PACIFIC GAS AND ELECTRIC COMPANY

PGandE Letter No.: DCL-84-239

Re: Docket No. 50-275, OL-DPR-76
Diablo Canyon Unit 1
Joint Intervenors' Allegations

Enclosed are Pacific Gas and Electric Company's responses to the allegations contained in affidavits which were attached to the Joint Intervenors' June 11, 1984 Reply to PGandE and NRC Staff Answers to Joint Intervenors' Motions to Reopen Design and Construction Quality Assurance.

Fig. B Straight Ruler Method
 The implied radius R_D
 is taken as the measured D dimension

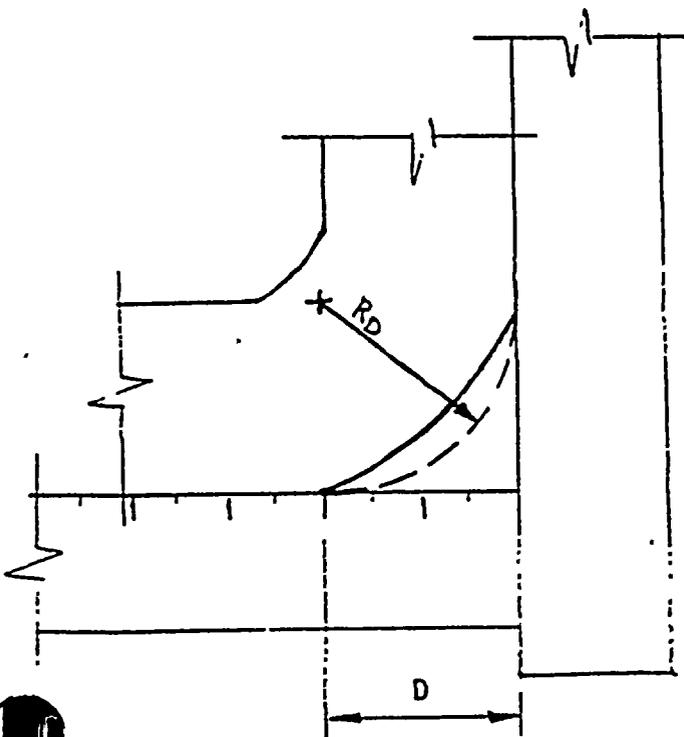
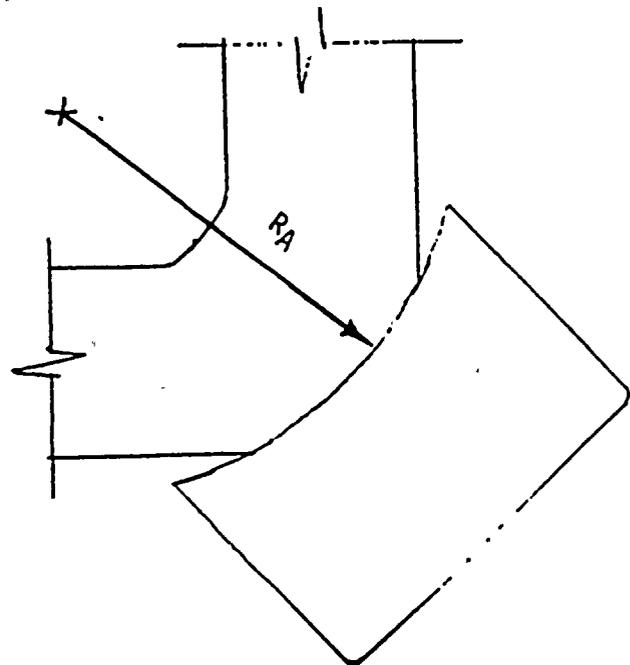
The curved portion of the tube corner is not fabricated to be exactly one quarter of a circle, as indicated by the dotted line in Figure A. In fact, it is actually less than a quarter of a circle as indicated by the solid line in the same figure. Therefore, different radii can be inferred for the tube corner dependent upon the measurement method used.

If a straight ruler or mechanic's square is used, as shown in Figure B a corner dimension, D , is measured. We have termed this the flat side intersection method (D dimension). Based on this D dimension, an apparent corner radius of R_D is implied. As shown in Figure B, this may not be the actual radius of curvature. Alternatively, if a concave radius gauge is used, the measured radius is R_A , as shown in Figure C. R_A is the appropriate measurement of the actual radius of curvature. Only when the tube corner is an exact quarter circle will the two measurement methods yield the same radius. Examples of tubes with the smallest corner dimension, D , were selected by the Pullman QC for further measurement. The resulting measurements are
